STAFF RECOMMENDATION 1831 4th Avenue North October 16, 2013

Application: New construction--infill
District: Salemtown Neighborhood Conservation Zoning Overlay
Council District: 19
Map and Parcel Number: 08108029700
Applicant: Infill Development Services, LLC
Project Lead: Melissa Baldock, melissa.baldock@nashville.gov

Elevations		H2
Date	4/19/12	
Drawn by	J. Feller	Scale 1/4" = 1'-0"

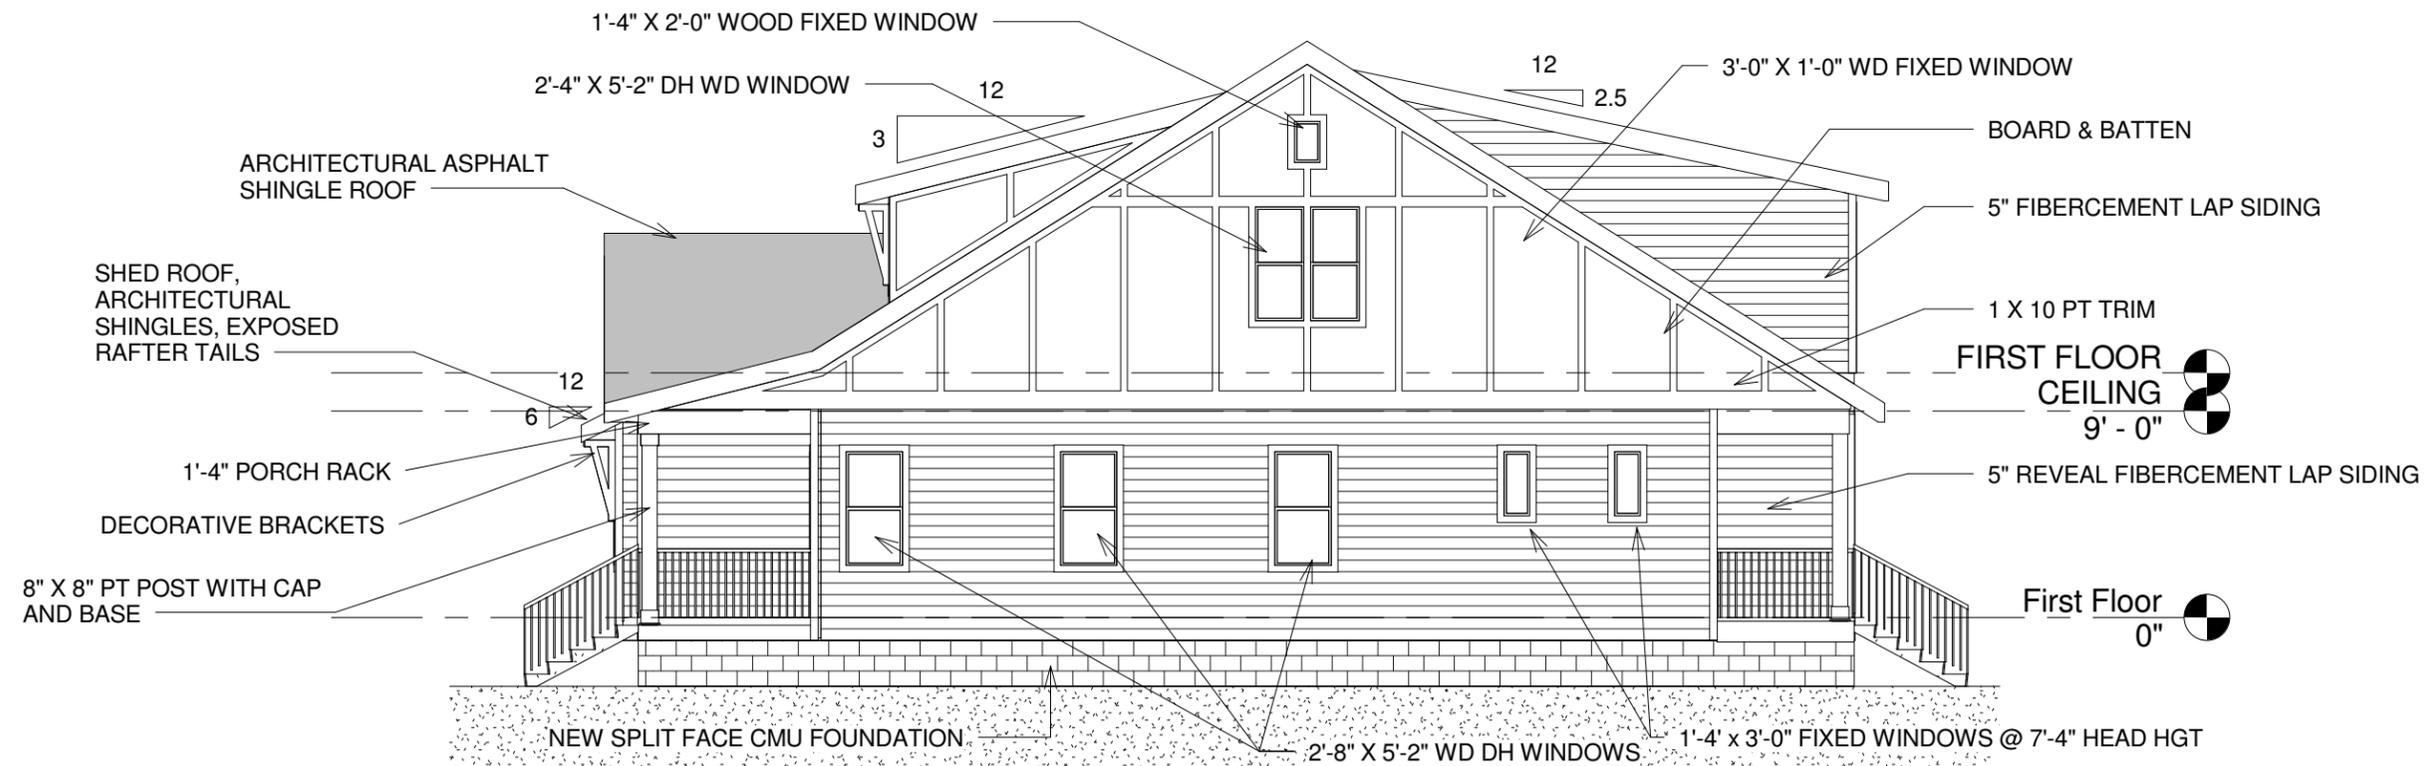
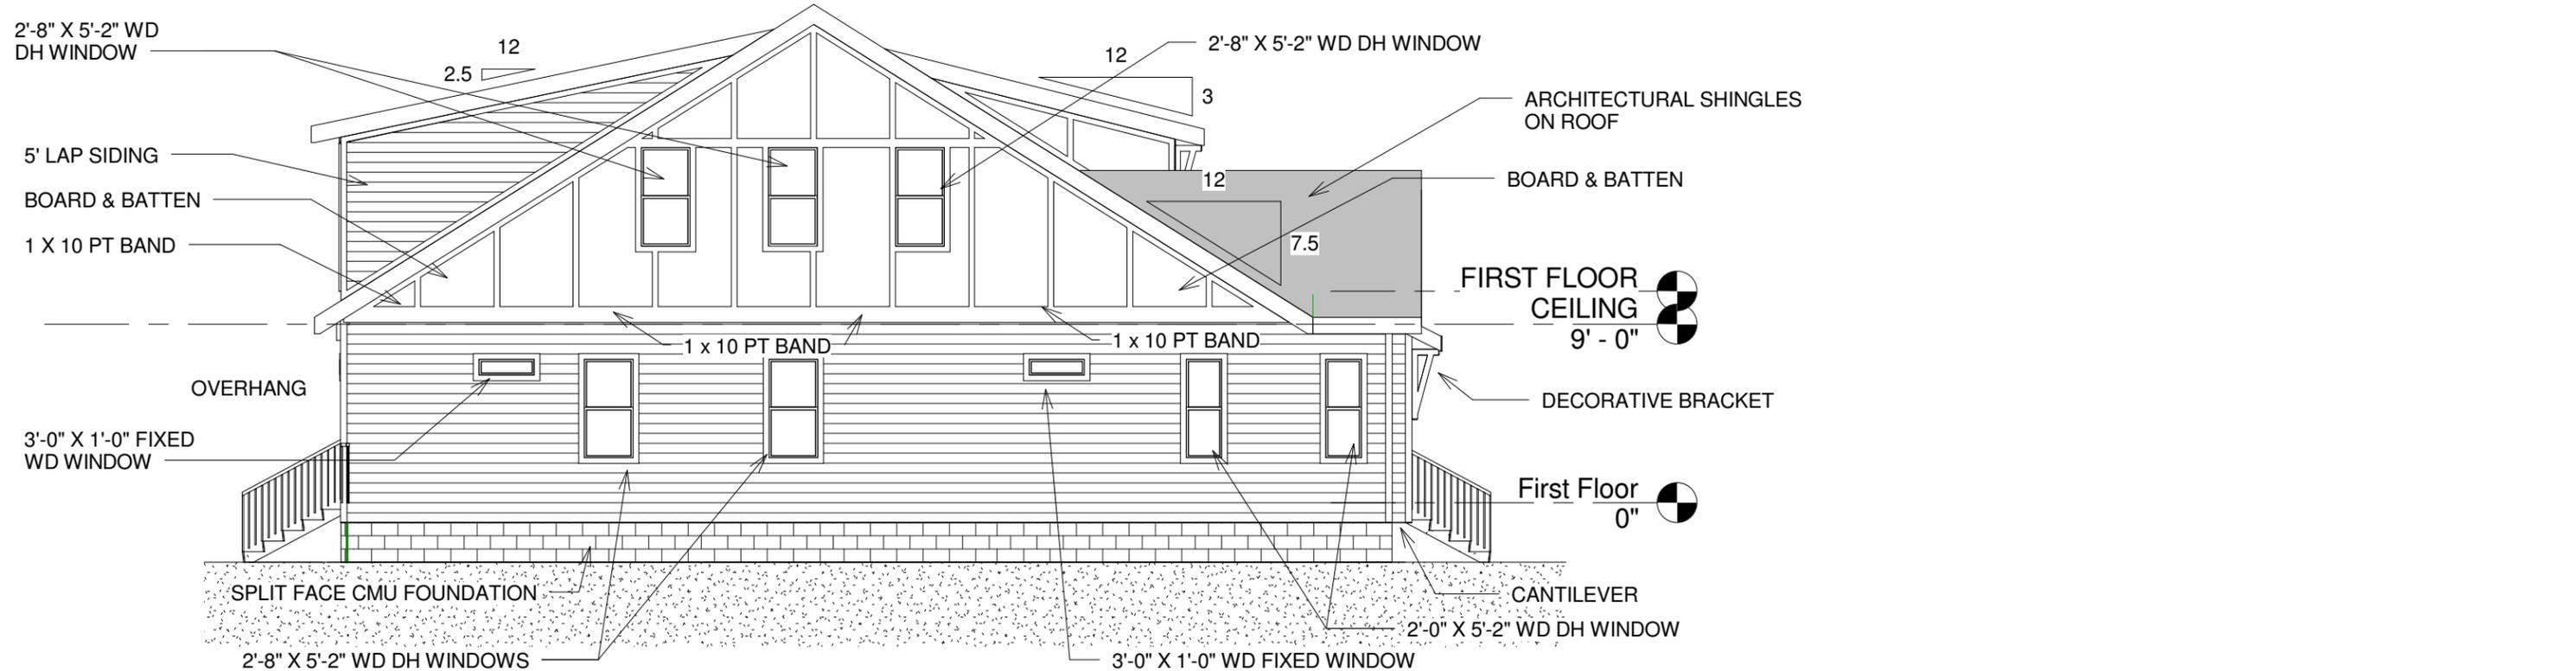
Orientation. The infill will be oriented to face 4th Avenue North with a walkway to the street, which is appropriate. It will have a slightly-off centered entrance behind a partial-width front porch. The front porch will be about seven feet, six inches (7'6") deep, which is appropriate, and will have a one foot (1') tall porch rack. Staff finds that the infill's orientation meets Section III.F. of the *Salemtown Neighborhood Conservation Zoning Overlay: Handbook & Design Guidelines*.

Materials. The primary cladding material for the infill will be five inch (5") cement fiberboard lap siding. Fiber cement board-and-batten is proposed as an accent material in the gable field and dormer. The decorative brackets and porch columns will be wood, and the trim will be wood or cement fiberboard. The foundation will be split face concrete block, and the roof will be architectural shingles. Staff asks to approve the roof color. The porch floor will be wood. The materials for the windows and doors were not specified, and staff asks to approve them before purchase and installation. With the staff's final approval of the roof color and all windows and doors, staff finds that the infill's materials meet Section III.D. of the *Salemtown Neighborhood Conservation Zoning Overlay: Handbook & Design Guidelines*.

Roof. The infill will have a gabled-el form. The front gable bay will have a 12/12 slope, while the side gable will have a slope of 7.5/12. The front dormer will have a shed roof with a 3/12 slope, and the rear dormer will have a 2.5/12 shed roof. The front porch roof

will be shed with a slope of 3/12. Staff finds that these roof forms and slope match the historic context. Staff therefore finds that the infill's roof form meets Section III.E. of the *Salemtown Neighborhood Conservation Zoning Overlay: Handbook & Design Guidelines*.

Proportion and Rhythm of Openings. The structure's primary windows are generally twice as tall as they are wide, thereby meeting the historic proportion of window openings. In addition, there are no large expanses of wall space without a door or window opening, and all double windows have a four inch (4") mullion in between them. Staff finds that the infill's proportion and rhythm of openings meet Section III.G. of the *Salemtown Neighborhood Conservation Zoning Overlay: Handbook & Design Guidelines*.

Recommendation Summary: Staff recommends approval of the project with the condition that staff review the roof color and the window and door specifications prior to purchase and installation. With this condition, staff finds that the infill meets Section III of the *Salemtown Neighborhood Conservation Zoning Overlay: Handbook & Design Guidelines*.
